HISTORIC AND DESIGN REVIEW COMMISSION

HDRC CASE NO: 2019-757
ADDRESS: 646 S FLORES ST
LEGAL DESCRIPTION: NCB 929 (ARSENAL(REPLAT)), BLOCK 3 LOT 6
ZONING: D, H, RIO-4
CITY COUNCIL DIST.: 1
DISTRICT: Arsenal Historic District
APPLICANT: Adrianna Swindle/Lake Flato Architects
OWNER: Todd Piland/BUTT H E GROCERY CO
TYPE OF WORK: Construction of a multi-story commercial structure
APPLICATION RECEIVED: December 20, 2019
60-DAY REVIEW: February 18, 2020
CASE MANAGER: Edward Hall
REQUEST:

The applicant is requesting conceptual approval to construct a commercial structure featuring between four and five stories and 170,000 square feet at 646 S Flores. The proposed new construction will be located on land that is currently a surface parking lot, within the Arsenal Historic District and the River Improvement Overlay, District 4. The proposed new construction will feature ninety-six (96) feet in height, and exceeds the allowable height for RIO-4, which is eighty-four (84) feet.

PHASE 1 SECTION PERSPECTIVE A - A

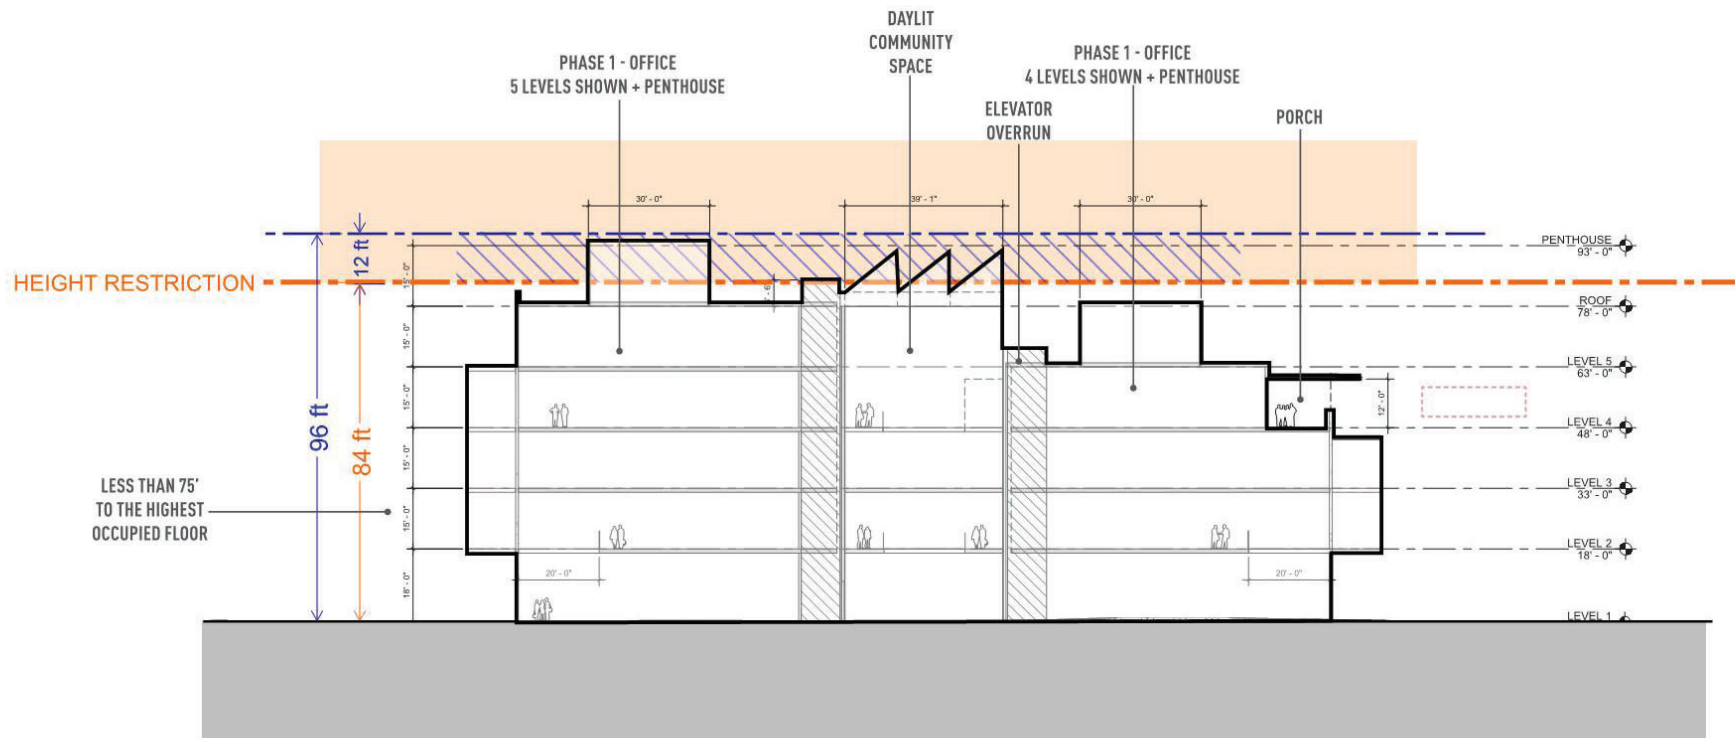
A. BUILDING HEIGHT: THE PROPOSED DESIGN FOR THE HEIGHT OF THE BUILDING WILL EXCEED THE MAXIMUM ALLOWED 84 FT. IN HEIGHT PER UNIFIED DEVELOPMENT CODE RIO 4 BUILDING DESIGN PRINCIPLE/TABLE 674-1.

A VARIANCE IS TO BE REQUESTED TO ALLOW FOR A HEIGHT IN EXCESS OF 84 FT.; PROPOSED MAXIMUM HEIGHT FOR THIS BUILDING IS 96 FT
